## Addendum #2

### **Kirkland Fire Department Training Structures**

Invitation for Bids #02-24-PW

#### Answers to Questions

3-Story Townhouse  
Training Prop  
Representation

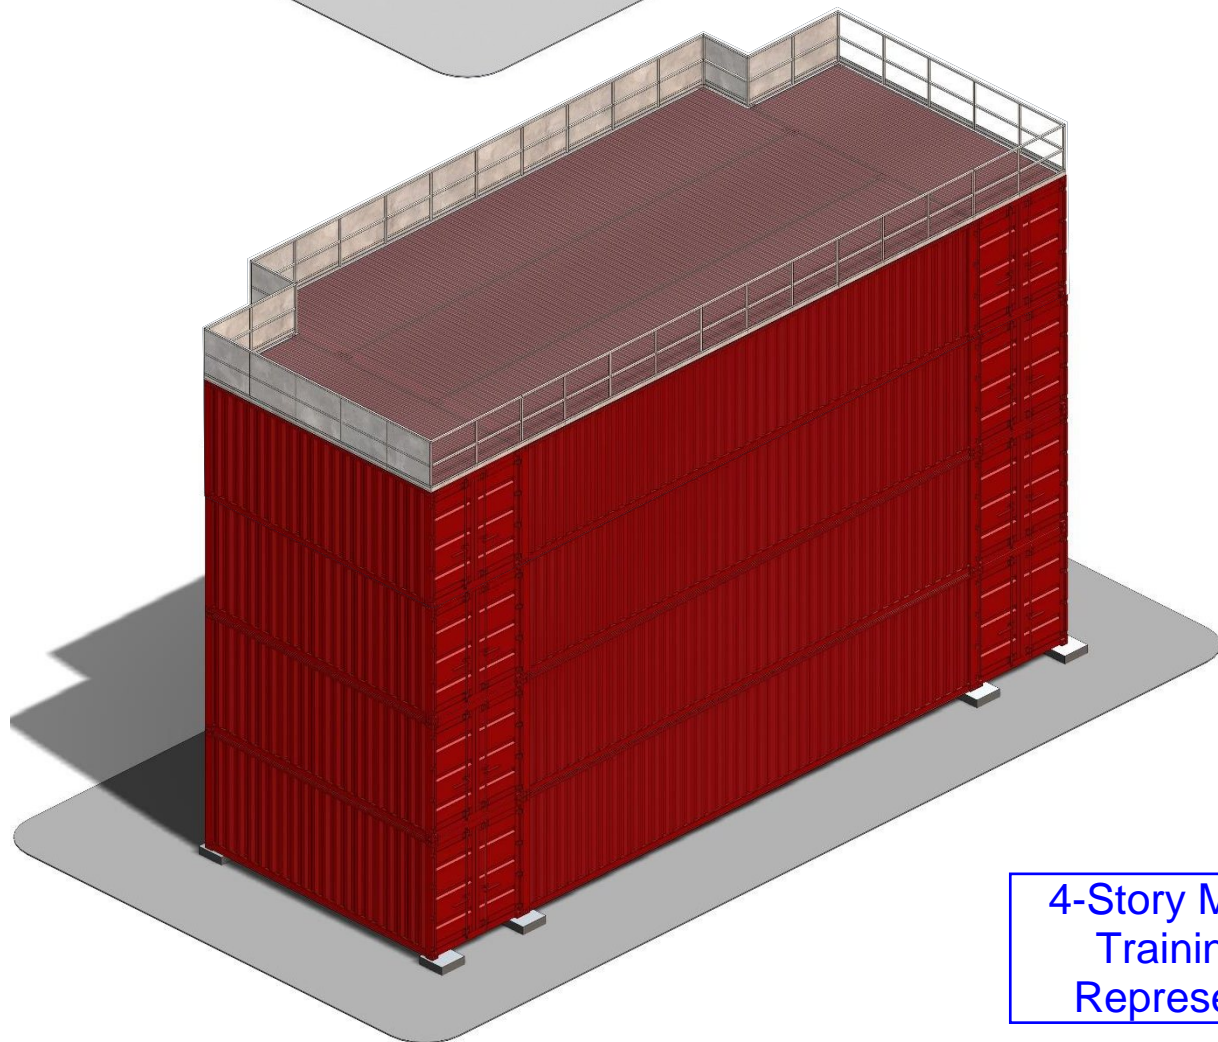
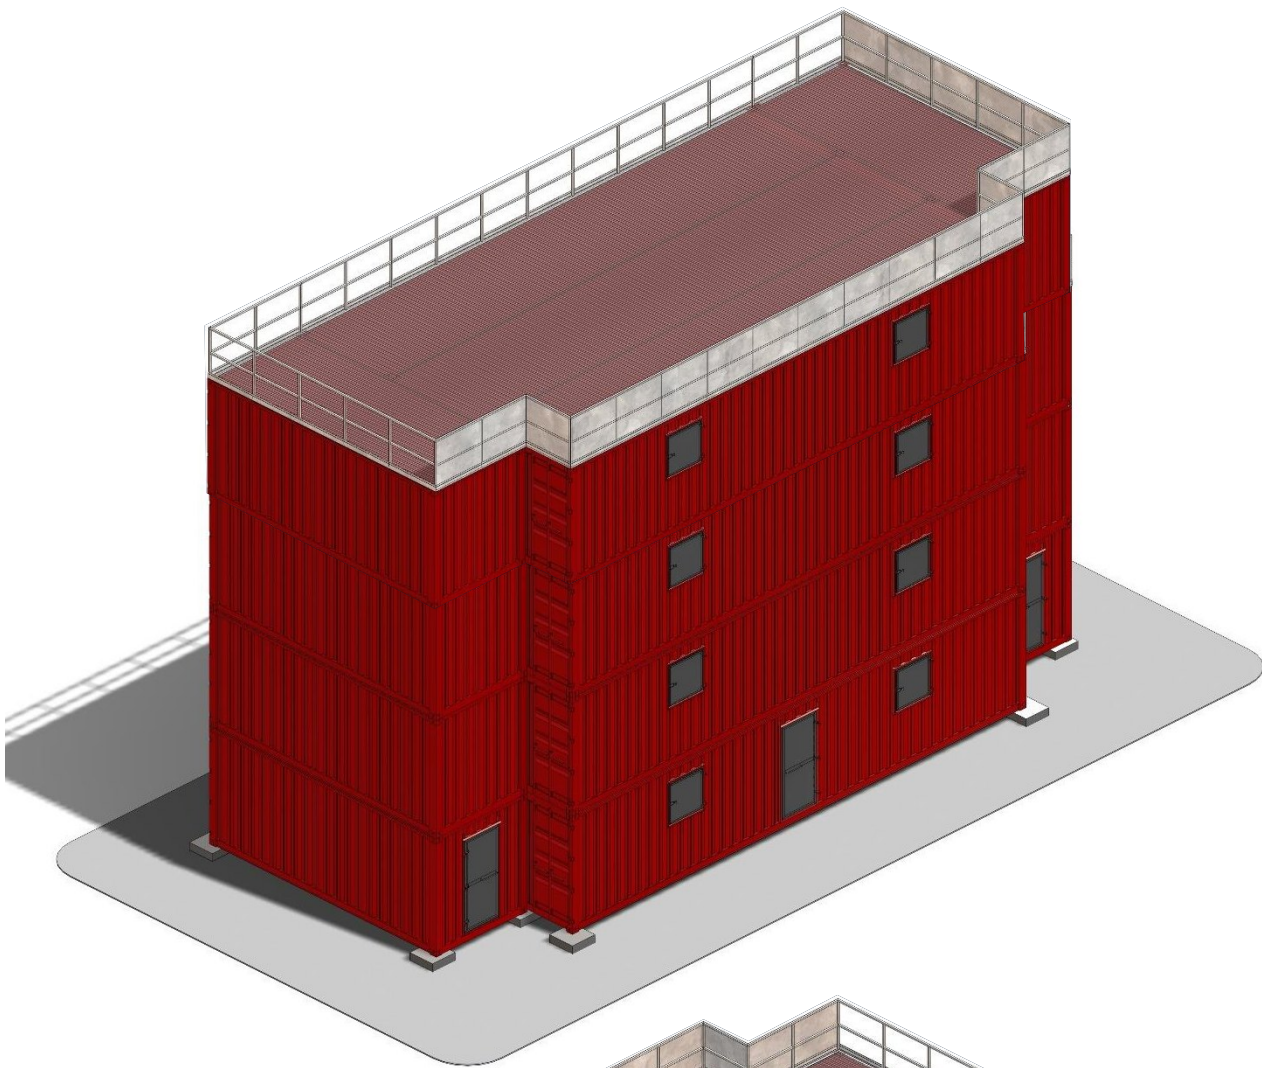
1. Q: Can you please clarify the number and size of Containers that are required for each of the three-stories of the Townhouse Training Prop (i.e. 2 x 40' and 1 x 20' on level one, .....)

4. Q: Both buildings call out a height in the spec, but there is no minimum footprint for the structure. Please advise on the minimum footprint or square footage required.

A: See renderings of the intended configuration. The training props shall include a mix of 20 ft and 40 ft containers to achieve the dimensions required: Townhouse Prop shall be 40 ft x 24 ft (nine 40 ft containers) and the Mixed-Use Prop shall be 60 ft x 24 ft (Nine 40 ft containers and six 20 ft containers).

A: See renderings of the intended configuration. The training props shall include a mix of 20 ft and 40 ft containers to achieve the dimensions required: Townhouse Prop shall be 40 ft x 24 ft (nine 40 ft containers) and the Mixed-Use Prop shall be 60 ft x 24 ft (Nine 40 ft containers and six 20 ft containers).

4-Story Mixed Use  
Training Prop  
Representation

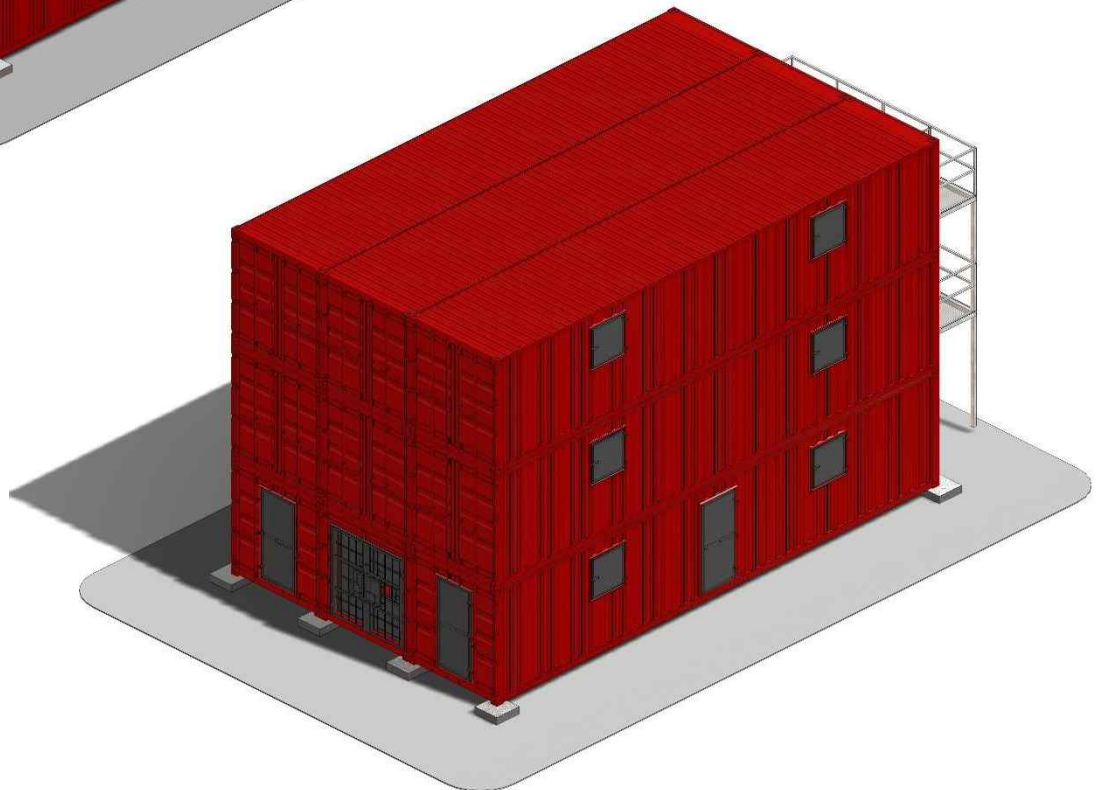
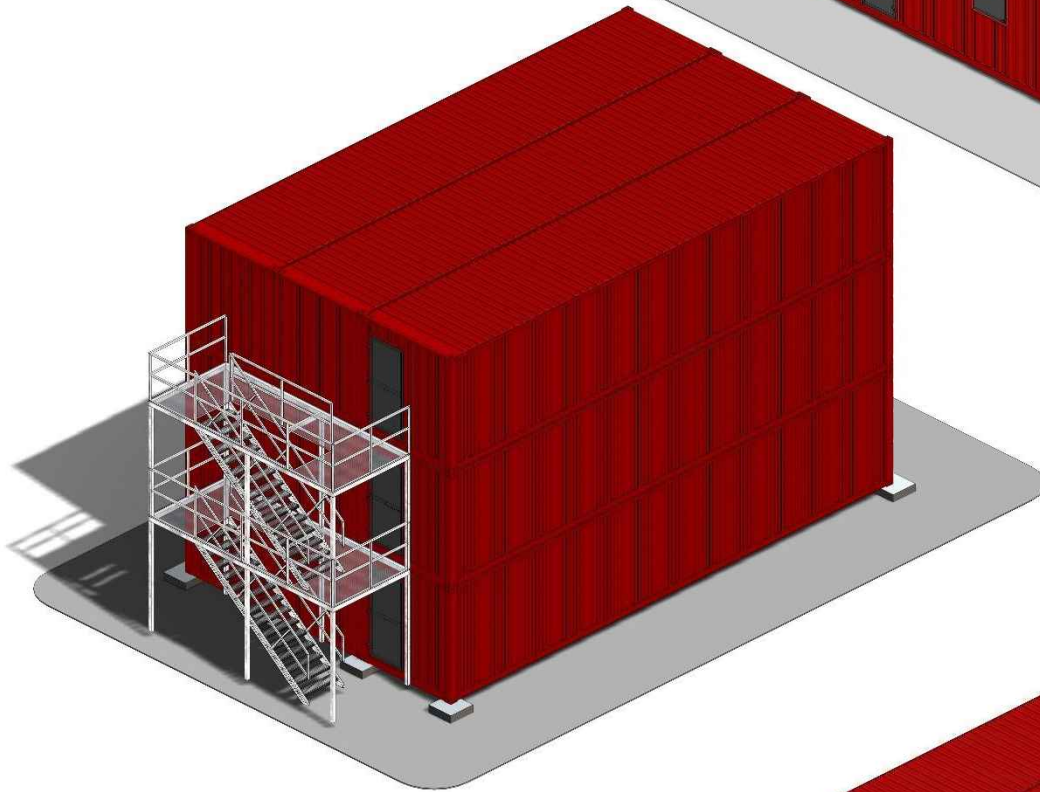
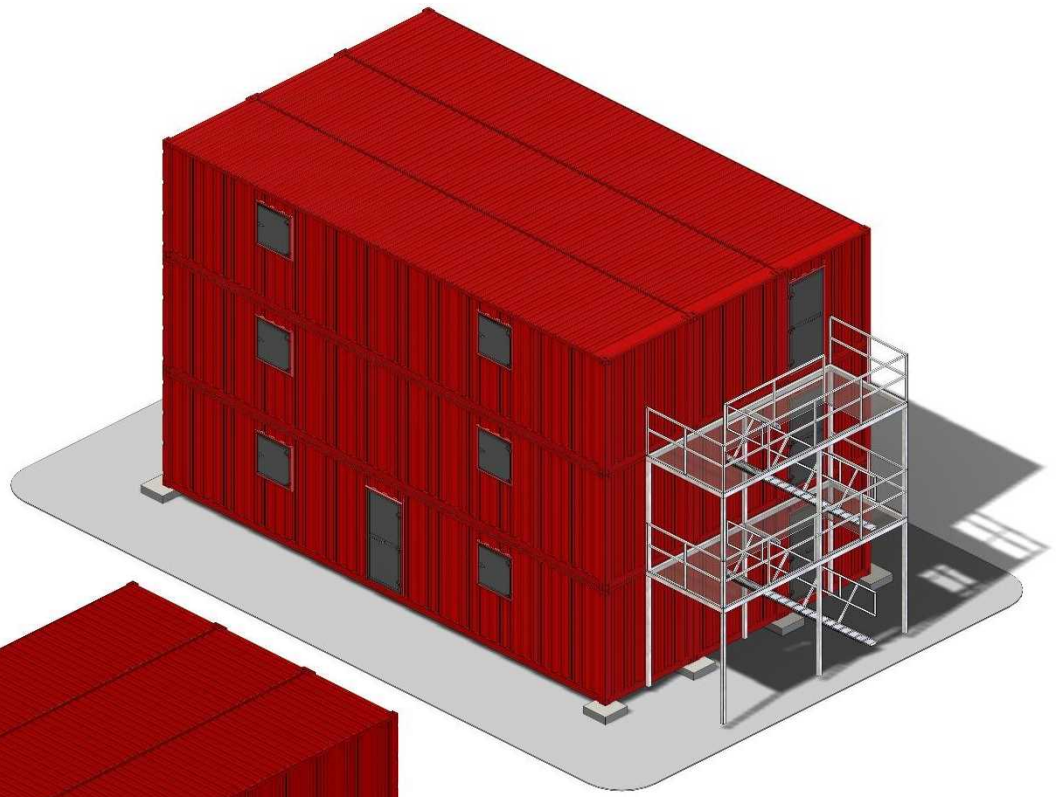
2. Q: Can you please clarify the number and size of Containers that are required for each of the four-stories of the Mixed-Use Training Prop.

18. Q. Is there a desired footprint and configurations for containers per story?

22. Q: Town House Training Prop: Where does the rappelling anchor need to be located? Stairs only go to the 3rd story. Does there need to be roof access to the "4th story" (deck) for rappelling?

A: See renderings of the intended configuration. The training props shall include a mix of 20 ft and 40 ft containers to achieve the dimensions required: Townhouse Prop shall be 40 ft x 24 ft (nine 40 ft containers) and the Mixed-Use Prop shall be 60 ft x 24 ft (Nine 40 ft containers and six 20 ft containers).

A: See renderings of the intended configuration. The training props shall include a mix of 20 ft and 40 ft containers to achieve the dimensions required: Townhouse Prop shall be 40 ft x 24 ft (nine 40 ft containers) and the Mixed-Use Prop shall be 60 ft x 24 ft (Nine 40 ft containers and six 20 ft containers).

A: Rappelling anchors should installed be on the Mixed-Use Prop, not the Townhouse Training Prop. Stairs to the fourth story; roof access to the 5th story. Four rappelling anchors should be provided on the roof that are in line with windows. Three rappelling anchors should be installed on the interior of the fourth story, in line with windows and in line with the roof rappelling anchors.
